Planning Application 22/04966/FUL - 23 St Alban's Road EH9 2LT

OBJECTION from Grange Association

18 November 2022

23 St Alban's Road EH9 2LT: 22/04966/FUL proposal to remove wall and create 5m wide parking area

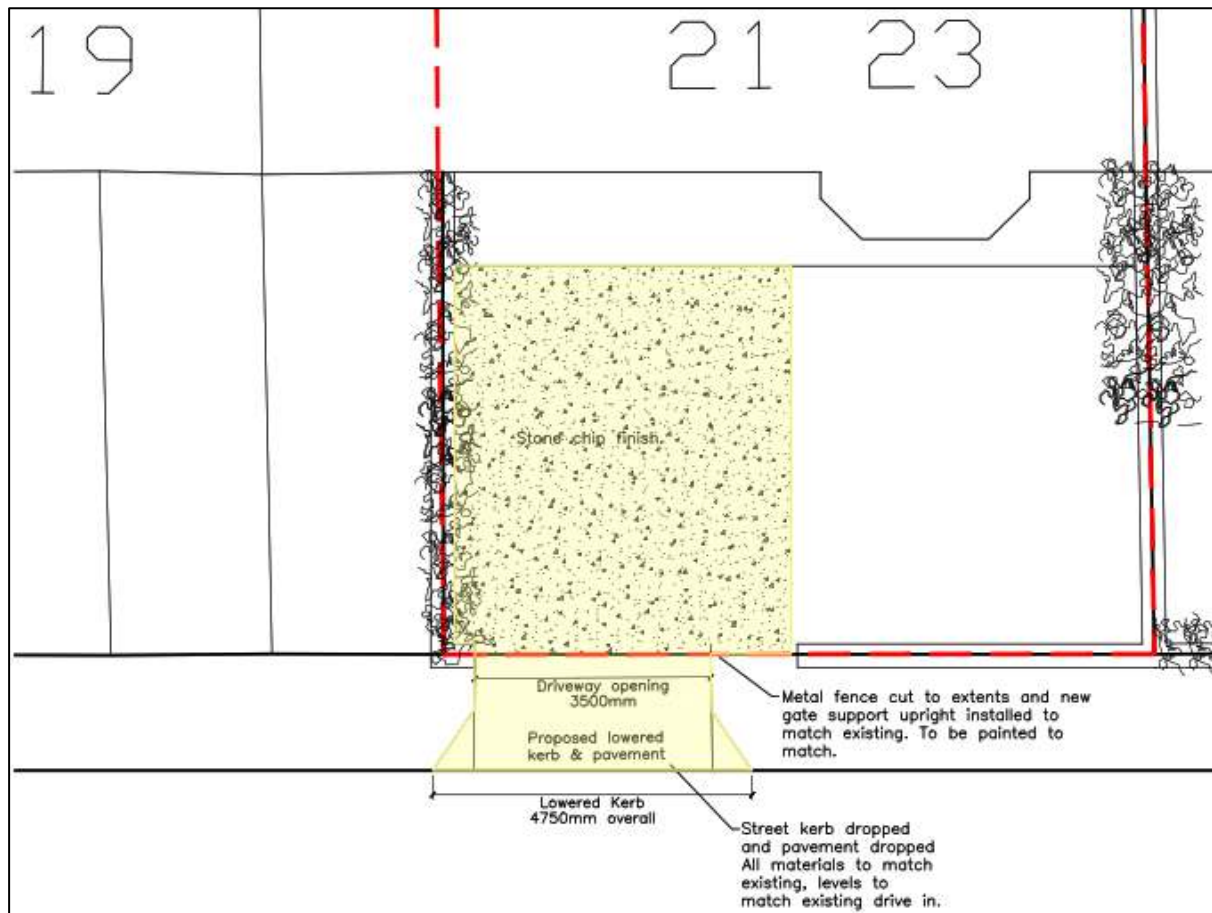
The opening for the new car parking space is shown on the plan drawing as 3.5m. However, the proposal is to remove all the grass to the East (left) of the pedestrian entrance path and to incorporate that pathway into a uniform stone chip area over 5m wide, sufficient for two vehicles to be parked side by side. This is greater than the maximum of 3m specified on page 19 of the Council's [Guidance for householders](#), referring to vehicle access.

We therefore request that the proposals be amended:

- to limit the loss of the front boundary wall to no more than 3m;
- to retain the existing pedestrian entrance gate;
- to comply in all other respects with the Householder Guidance (page 19):
 - The design should be such as to prevent additional parking on the remainder of the garden area, eg by using kerbs, planting boxes or changes of level;
 - the first 2 metres from the road should be paved to avoid loose chippings spilling out.
